**STATE OF NORTH CAROLINA  
UTILITIES COMMISSION  
RALEIGH**

DOCKET NO. E-100, SUB 179

In the Matter of:		
Duke Energy Progress, LLC, and Duke	)	JOINT COMMENTS OF
Energy Carolinas, LLC, 2022 Biennial	)	NC WARN AND THE
Integrated Resource Plans and Carbon Plan	)	CHARLOTTE
	)	MECKLENBURG NAACP

<sup>45</sup> Carbon Plan, Appendix E, p. 40, Figure E-6: Base Henry Hub Natural Gas Price Forecast [\$/MMBTU]

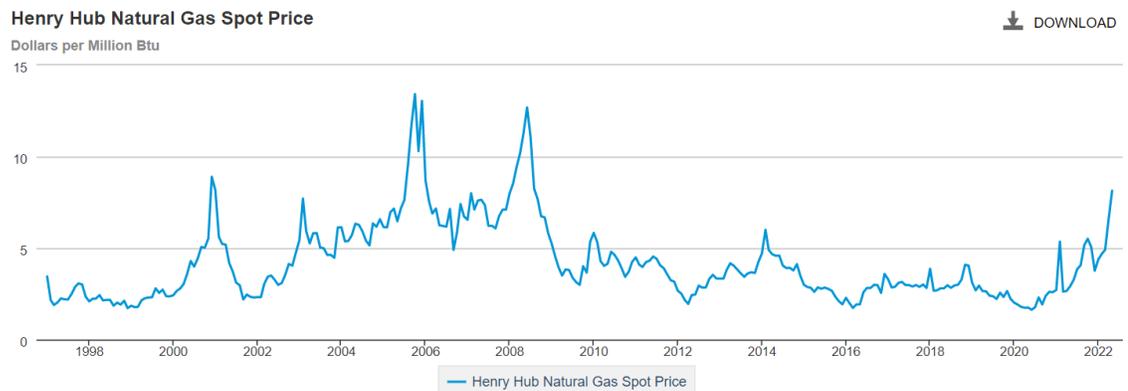
The Companies’ proposed natural gas buildout is further problematic because of the Carbon Plan’s unreasonably optimistic projection of future natural gas prices. The Carbon Plan assumes a low base price for natural gas of under \$4/MMBtu through 2032, rising to \$5/MMBtu in 2040. The Carbon Plan included Figure E-6, which depicted a Henry Hub natural gas price forecast utilized in the Carbon Plan modeling. Figure E-6 from the Carbon Plan is as follows:<sup>45</sup>

The Carbon Plan modeling of natural gas pricing does not properly account for the substantial price volatility which is presently inherent to the natural gas market. Below is a figure taken from Mr. Powers' Report which reflects the substantial historic Henry Hub benchmark natural gas price volatility:<sup>46</sup>

According to Mr. Powers, “[n]atural gas prices have been especially volatile in 2022, with the May 2022 Henry Hub price over \$8 per million Btu.”<sup>47</sup> In fact, “Western Europe has become a high demand priority delivery point for U.S. natural gas in the form of LNG in the wake of the Ukraine war, driving increases in U.S. natural gas prices.”<sup>48</sup> Given these circumstances, the Companies’ projection of natural gas prices is unreasonably optimistic and should be rejected.

(f) The Companies should correct their unrealistic natural gas price projections.

**Figure 8. Comparison of Duke Energy actual demand growth to forecast demand growth<sup>78</sup>**

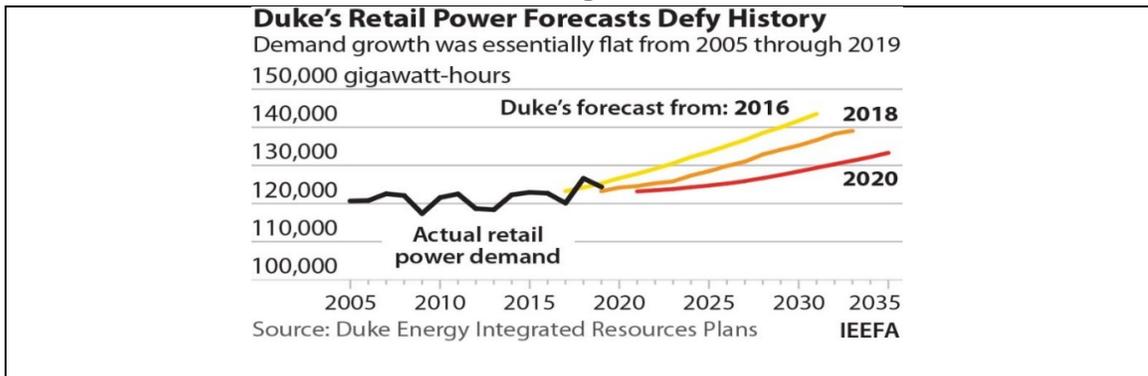
The Companies’ proposed natural gas buildout is largely based upon the purported need for new generation assets due to the substantial projected demand growth predicted in the Carbon Plan.<sup>77</sup> At the outset, it should be noted that the Companies have consistently overstated their demand growth during the last several Integrated Resource Plan proceedings, and the Companies’ aggressive projections have not come true. The following Figure 8, cut-and-pasted from Mr. Powers’ Report, illustrates the Companies’ history of overstating demand growth:

Actual retail sales growth for DEC from 2016 through 2021, which is the most recent five-year period shown in the Carbon Plan, averaged 0.0 percent.<sup>79</sup> Instead of using this period, the Companies opted to analyze the period of 2012 to 2021 and thereby assert a sales growth rate forecast for DEC of 0.8 percent.<sup>80</sup> This number is skewed and unreliable because 2012 was an unusually low retail sales year, as reflected in the above-provided Figure 8.<sup>81</sup> By arbitrarily beginning the calculation of demand growth on 2012, the Companies were able to project a demand growth for DEC of 0.8 percent. However, the most recent—and reliable—trends, namely over the last five (5) years, reflect an average annual growth of 0.0 percent.<sup>82</sup>

A similar analysis applies to DEP. The Carbon Plan shows that retail sales for DEP declined from 2016 through 2021, the most recent five-year period, at a rate of -0.7 percent.<sup>83</sup> Hence the Companies arbitrarily expand their analysis to the 2012-2021 time period.<sup>84</sup> As noted, 2012 was an unusually low retail sales year. By pegging the analysis to 2012, the Companies project demand growth for DEP of 0.4 percent. This projected demand growth seemingly ignores that, over the last five (5) years, DEP's retail sales have declined at a rate of -0.7 percent.<sup>85</sup>

(l) The Companies should correct the above-described errors with their demand growth rate forecast.

(m) Based upon the results of the above-stated corrections, the Commission should require the Companies to revise and reduce their demand growth rate forecast.
